AURIX™ TC37xEXT errata sheet

Marking/Step: (E)ES-AB, AB

About this document

Figure 1 Message buffer transfer from Message RAM to OBF

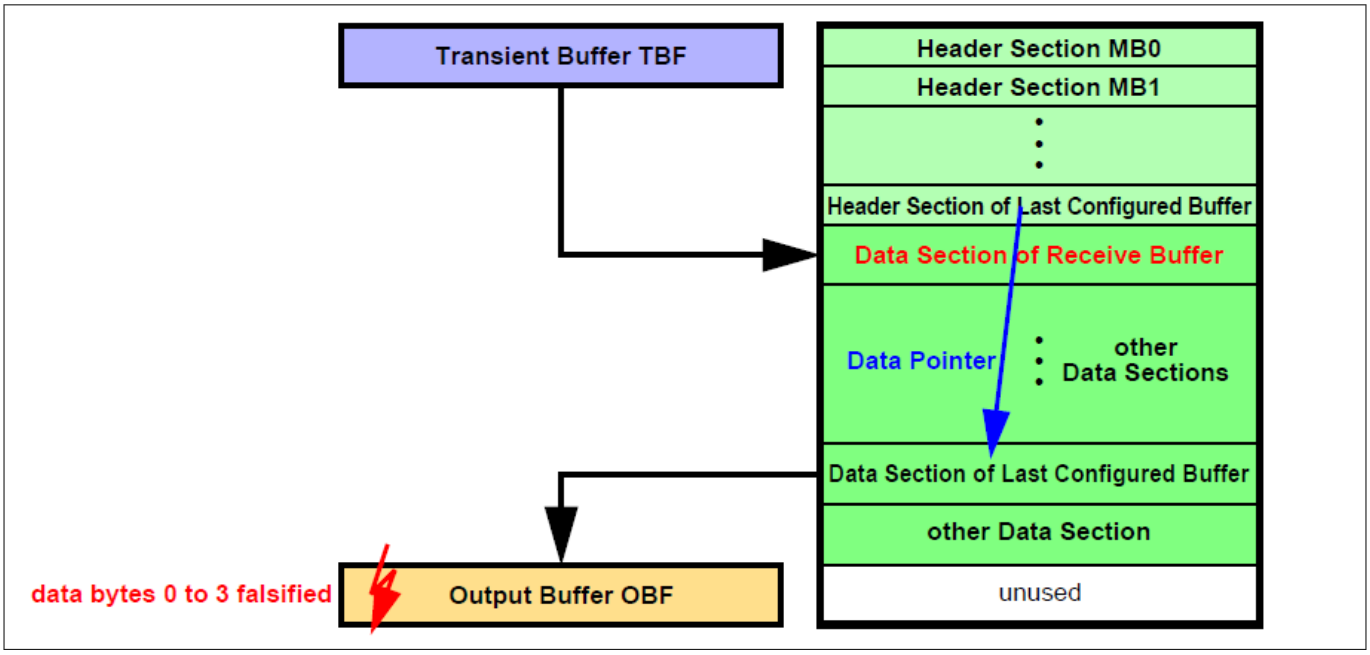
When the message buffer has its payload configured to maximum length (PLC = 127), the OBF word on address 00h (payload data bytes 0 to 3) is overwritten with unexpected data at the end of the transfer.

a) When a message is transferred from the Last Configured Buffer in the Message RAM to the OBF and PLC = 127 it may happen, that at the end of the transfer the OBF word on address 00h (payload data bytes 0 to 3) is overwritten with unexpected data (see Figure 1)

Figure 2 Message buffer transfer from IBF to Message RAM

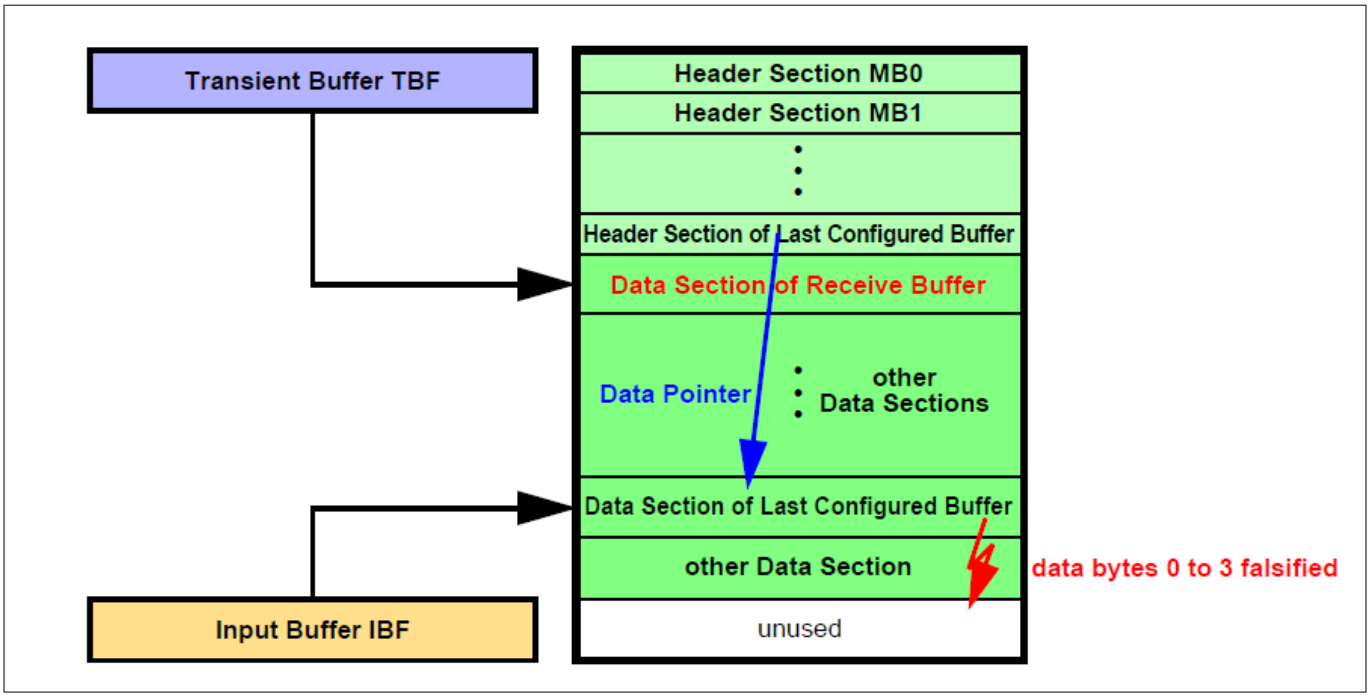
After the Data Section of the selected message buffer in the Message RAM has been written, one additional write access overwrites the following word in the Message RAM which might be the first word of the next Data Section.

b) When a message is transferred from IBF to the Last Configured Buffer in the Message RAM, it may happen, that at the end of the transfer of the Data Section one additional write access overwrites the following word, which may be the first word of another message's Data Section in the Message RAM (see Figure 2)

Figure 3 Message RAM configurations

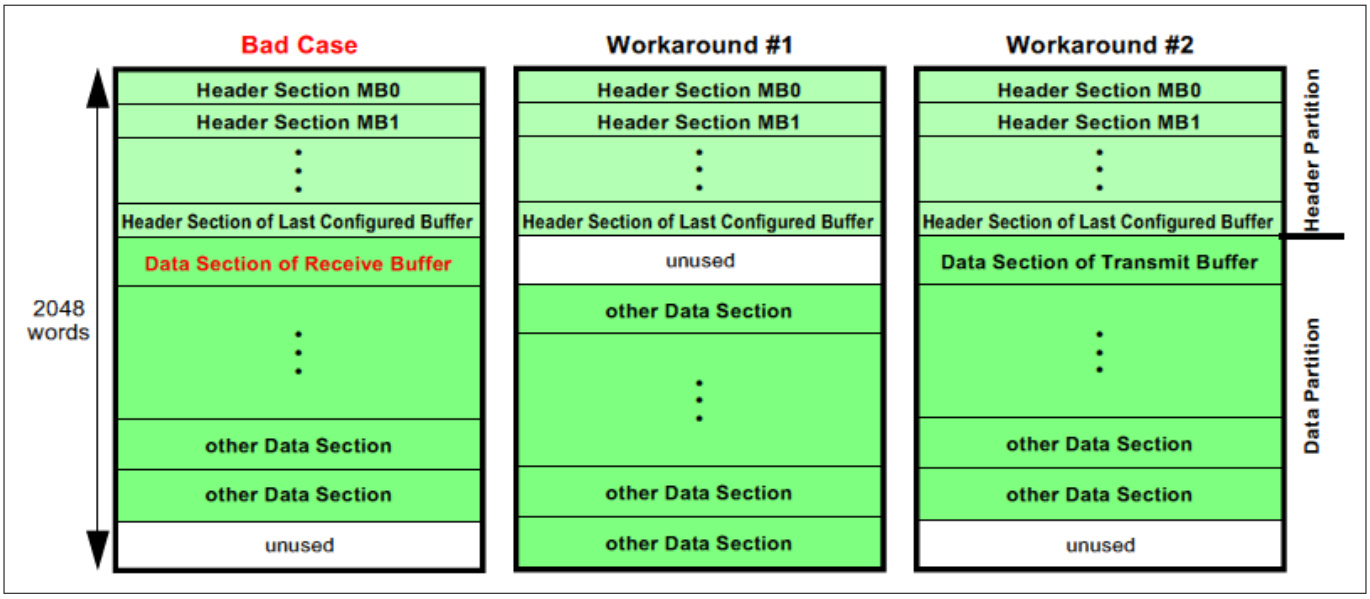
The erratum is limited to the case when (see Figure 3 “Bad Case”):

Ensure that the Data Section directly following the Header Partition is assigned to a transmit buffer.

Figure 6 Critical MCS AEI master scenario

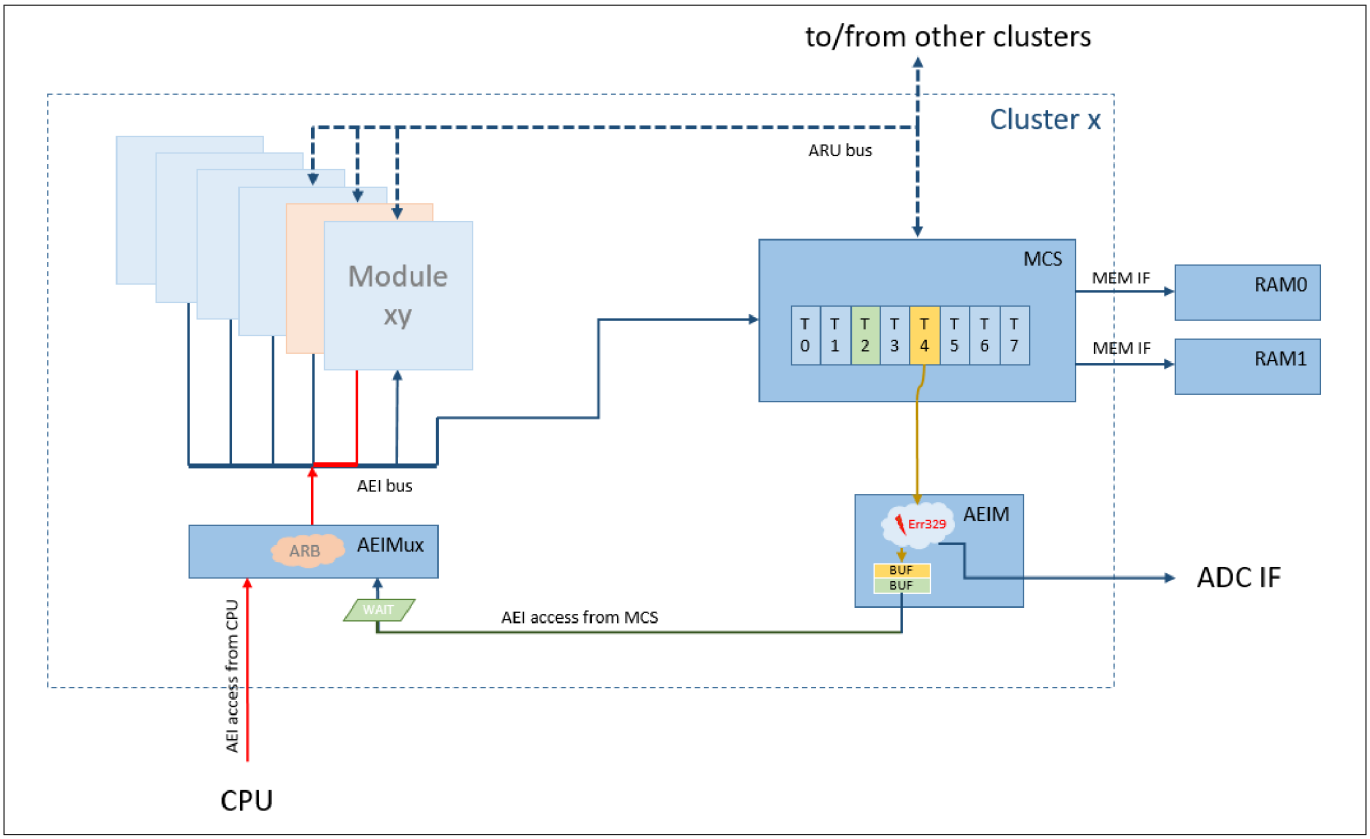
In Figure 6, a potential risk for the occurrence of problem GTM_AI.329 is illustrated. Here the first buffer of the AEIM (green) is still waiting for the access to the AEI bus while a second AEI bus access from MCS arrives at the AEIM (yellow access path). Under certain, but for the user unpredictable timing conditions, this second AEI bus access arriving at the AEIM can trigger the misbehavior described in problem GTM_AI.329.

The workarounds described in the 'Workaround' section will ensure that not more than one AEIM buffer will be filled and therefore the occurrence of problem GTM_AI.329 is avoided. All workarounds have been tested and proven correct.

Figure 7 MCS token mechanism

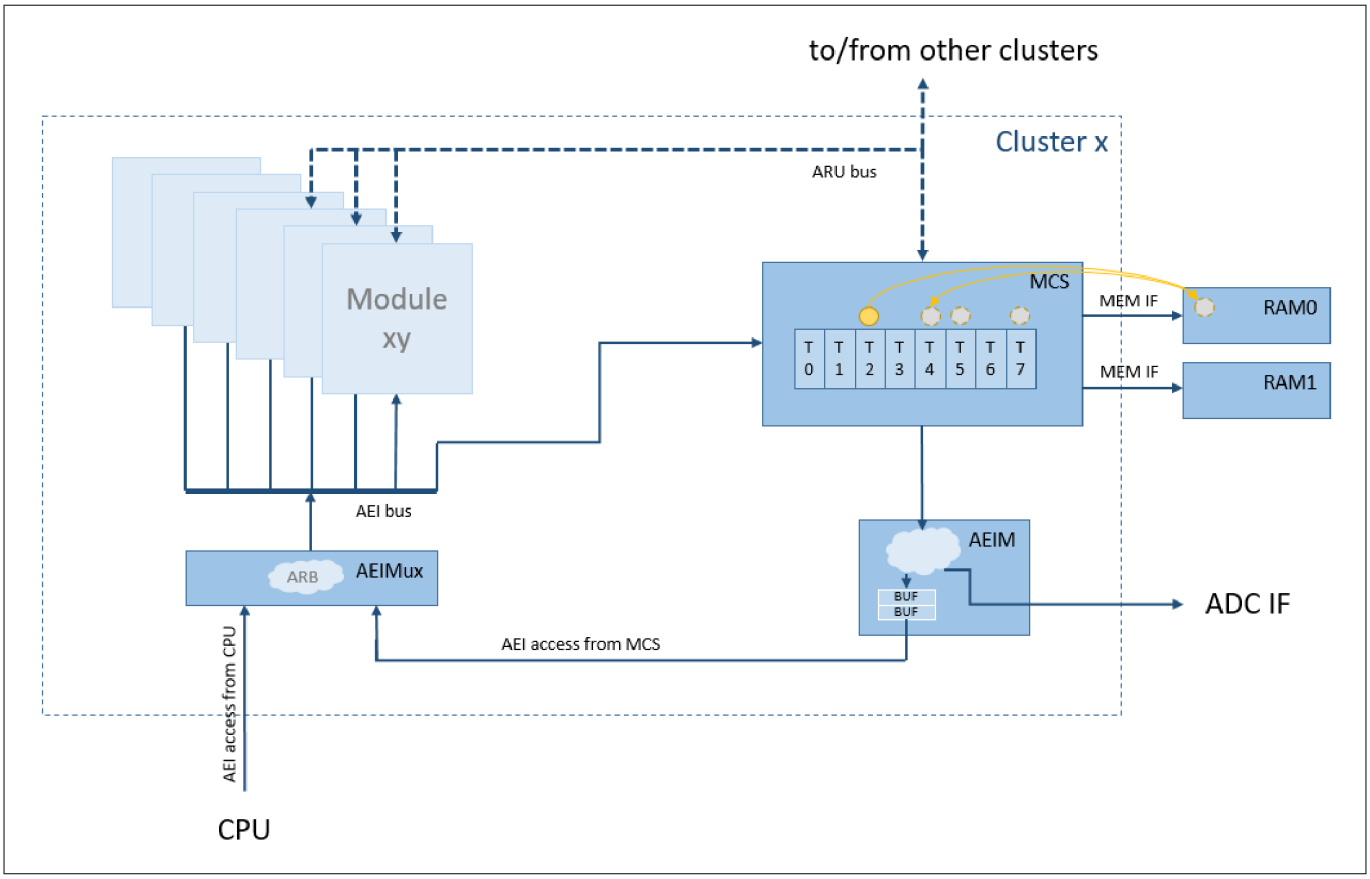
In case multiple MCS channels want to use the AEI master port for AEI or ADC communication, establish a mechanism that ensures that only one channel uses the AEI master at a time (e.g. exchange a token between channels or use trigger registers to hand over the AEI master port ownership between MCS channels).

Limit the usage of the MCS AEI master port (ADC and AEI communication) to one MCS channel per MCS at a time. ARU communication is available for all MCS channels and there are no limitations for the CPU access path in this usage model.

Figure 8 TBU value evaluation MCS against other modules. Red (past) and green (future).

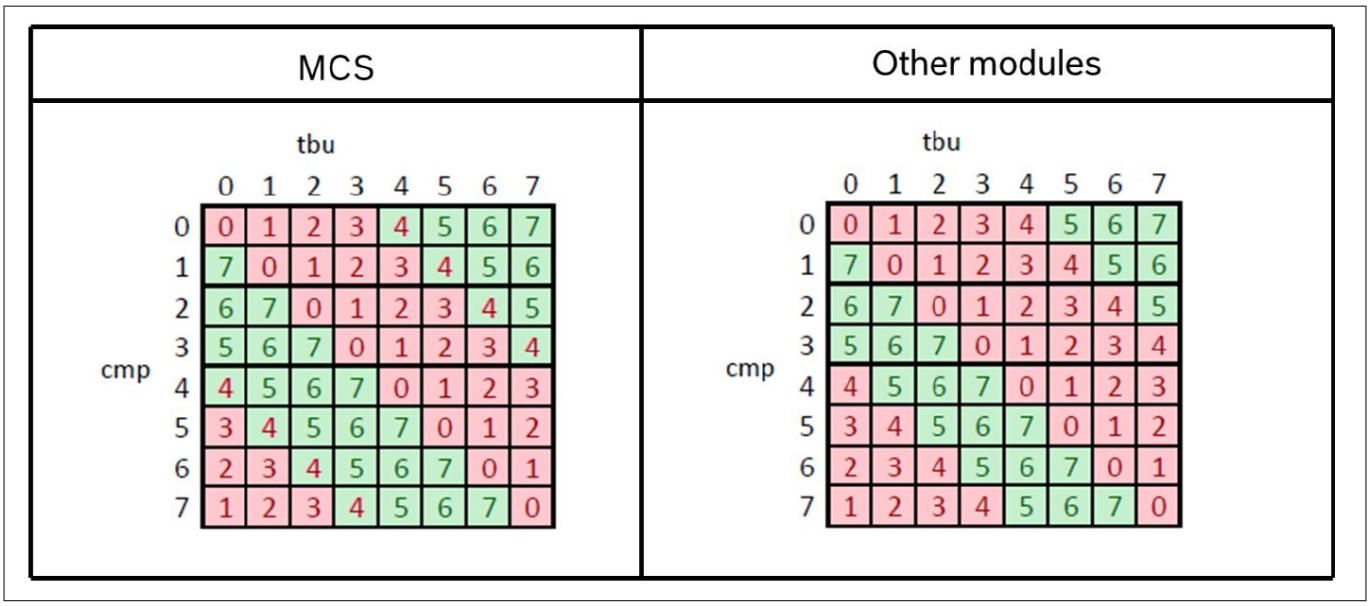
With the revised specification of GTM 4.1 it was revealed that the implementation for the WUCE instruction is not correct for the boundaries. The implementation of the WUCE instruction has an inverted behavior for both boundaries between future and past.

Figure 10 CAN Frame with DLC > 4

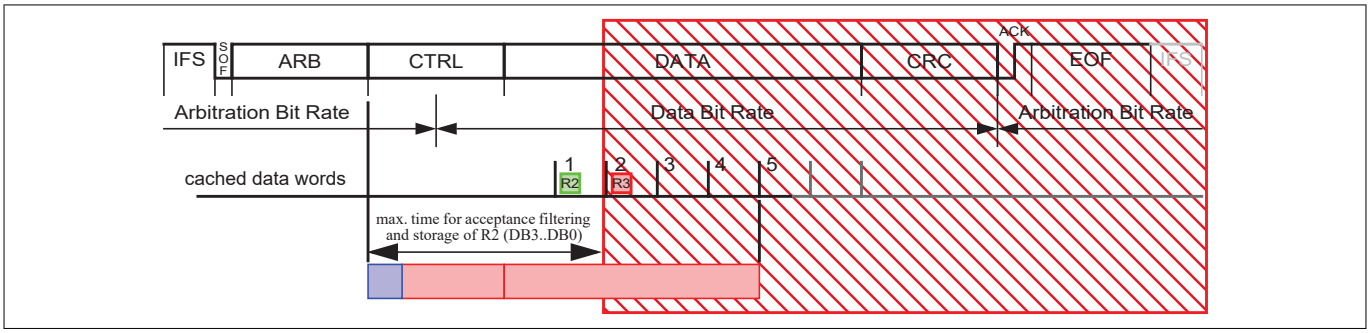
The issue may occur in FD Frame Format as well as in Classic Frame Format.

The figure that follows shows how the available time for acceptance filtering and storage is reduced.

Figure 11 Interrupt Level vs. Pulse-Notify mode - Corner Case Example

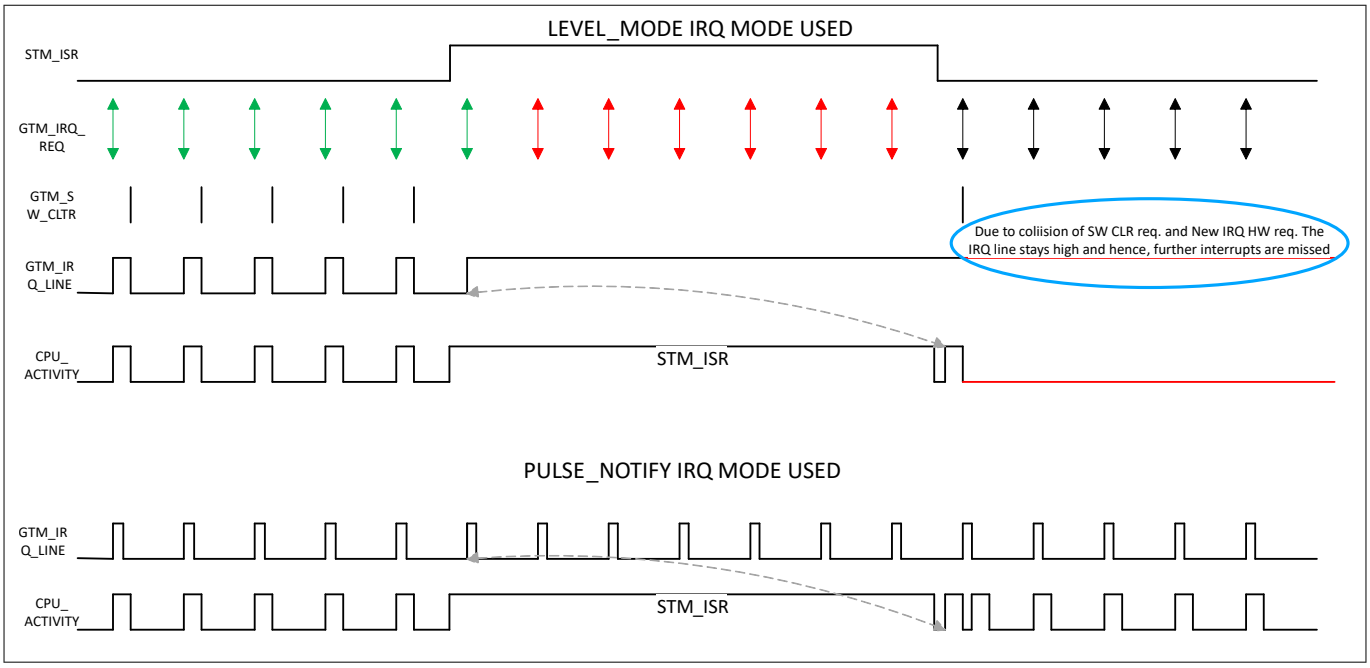
Hence, in Level Mode, in some scenarios where another interrupt request is generated by GTM while the ISR handle also requests a SW clear, then, as the interrupt event is dominant over the clear event (for simultaneous

interrupt and clear events), GTM_IRQ_XXX is not cleared and remains high. As a consequence, the IR observes no transition on GTM_IRQ_XX. Thus, any forthcoming interrupt events in this scenario are lost as there is no chance to release the CPU IRQ when a collision happens as shown in Figure below.

If Pulse-Notify mode is selected, every internal trigger will be forwarded to the IR, irrespective of the time of occurrence and the clear event, as the pulse-notify leads to set and reset of GTM_IRQ_XXX as compared to only setting of the GTM_IRQ_XXX line in Level mode.

Figure 12 Timing of LVDS TX interface command sending in relation to IRQ.IFCFS

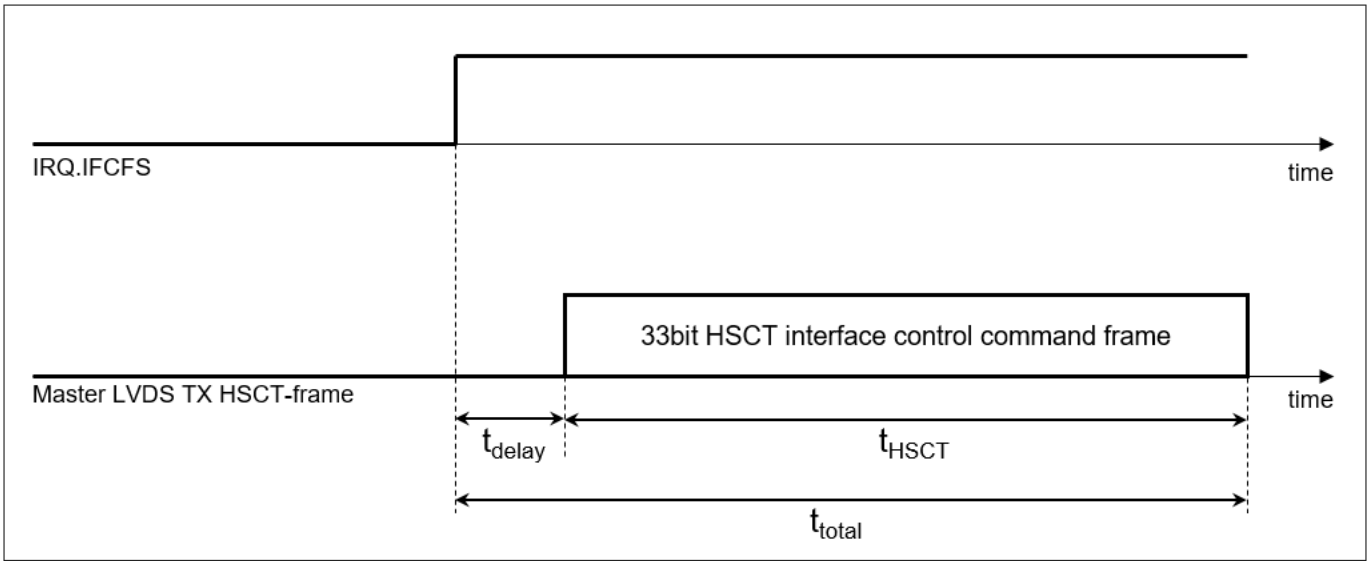
the user might falsely assume that also the actual sending on the LVDS TX port has already occurred once the IRQ.IFCFS flag is set, which is not true.

Instead the timing shown in the following figure applies.

Figure 13 Package Outlines LQFP-176 for TC37xEXT

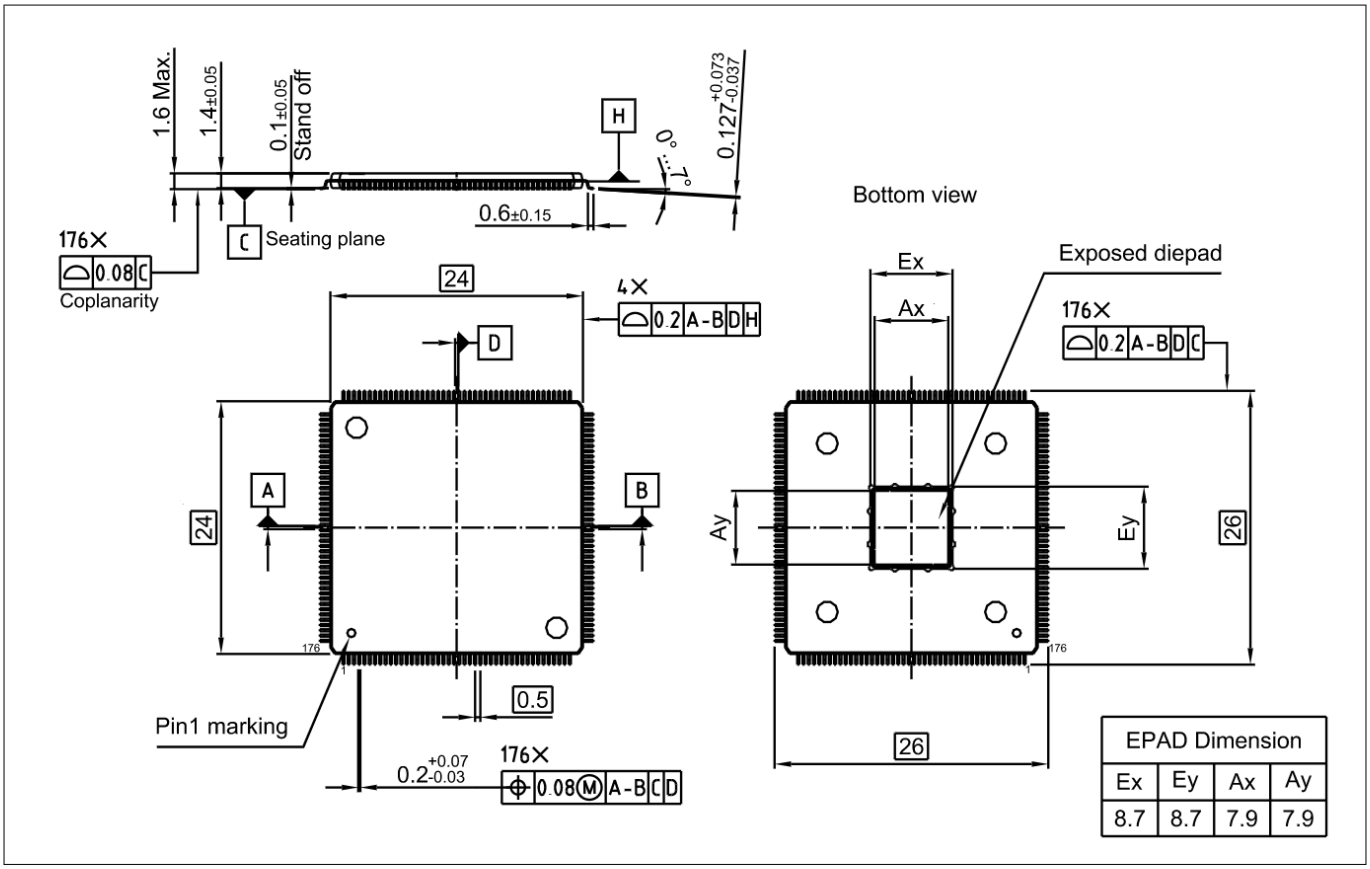
Furthermore, for the exposed die pads, the maximum boundary of the structural corner protrusions to be considered during system design and integration has been added.

This information shall substitute the corresponding information in the TC37xEXT AB-step Data Sheet V1.1.

***Note**: For the exposed diepad of the LQFP-176 package of the TC37xEXT, structural corner protrusions have to be considered for purposes of system design and integration with a maximum boundary of 9.4 mm.*
